Appl. No. 10/708,157
Amdt. dated September September 26, 2005
Reply to Office action of July 11, 2005

Amendments to the Drawings:

REMARKS/ARGUMENTS

Fig. 16

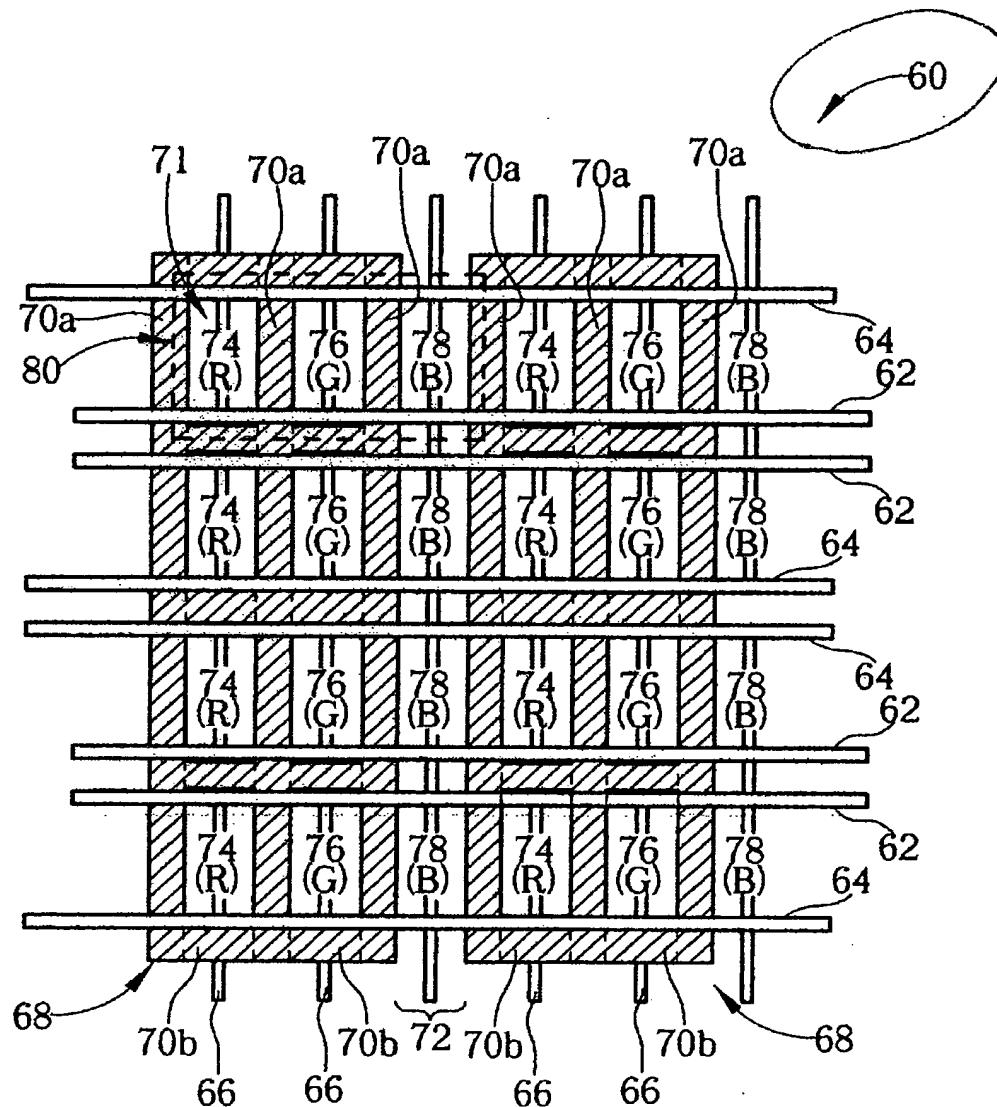
Changes to the drawings 2, 16-17 include adding some of the item label numbers and these changes are detailed in the REMARKS section of this response. No new matter has been introduced.

- (1) #14 in Fig. 2, depicting rear substrate in page 2 of the specification,
- 10 (2) #60 in Fig. 16, depicting PDP of the fifth embodiment in paragraph 0028 of the specification,
- (3) #90 in Fig. 17, depicting PDP of the sixth embodiment in paragraph 0030 of the specification.
